Date: 7th February 2025
My Ref: 20040633
Your ref: TR050007-002567
Contact: [REDACTED]
Phone: [REDACTED] [@leics.gov.uk](mailto:[REDACTED]@leics.gov.uk)

Planning Act 2008 - Application by Tritax Symmetry (Hinckley) Limited for the proposed Hinckley Rail Freight Interchange Development Consent Order

Further to your consultation letter dated 20 December 2024, please find attached our comments on the additional information submitted by Tritax Symmetry (Hinckley) Limited on 10 December 2024.

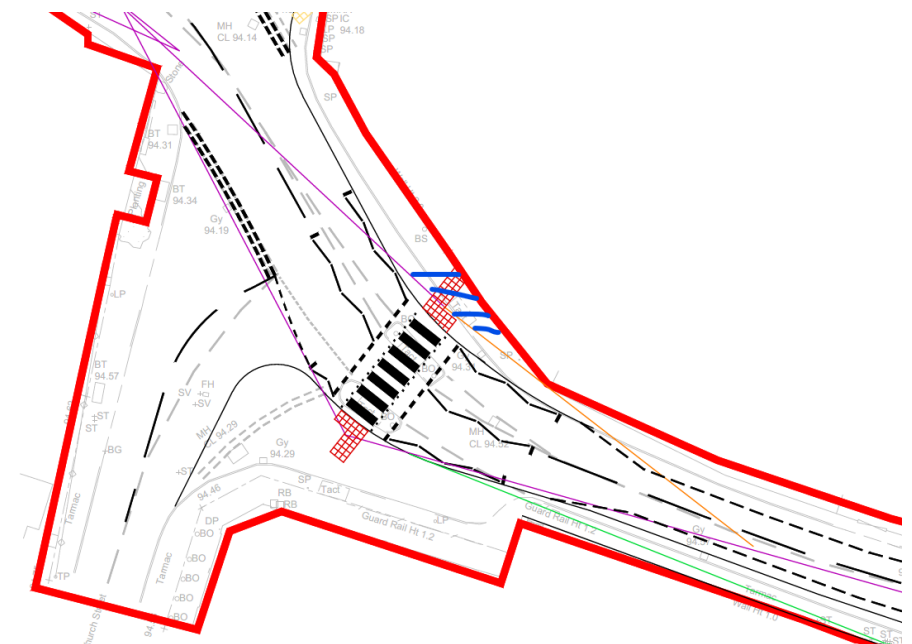
Highway safety concerns were also raised within the original RSA [REP8-025] in respect of forward visibility to the proposed zebra crossing. The Applicant has submitted a drawing [Sapcote enhanced scheme visibility to pedestrians] within Appendix C of the Technical Note attempting to show that vehicle to pedestrian visibility is not an issue. However, this is not the case.

In the extract below, the SoS will note that any pedestrian stood within the blue hatched area will not be visible to oncoming vehicles from the east or vice versa given the prevalence of an existing building line. There will realistically be pedestrians waiting in this area stepping back from the kerbline that will be over-ran by large vehicles, as a consequence of a number of pedestrians wishing to cross at any one time, or as a carer pushing a buggy or a wheelchair. Indeed, the Applicant has measured a setback of 1.2m contrary to the DfT guidance on Inclusive Mobility³ that identifies dimension requirements for vulnerable users in excess of this.
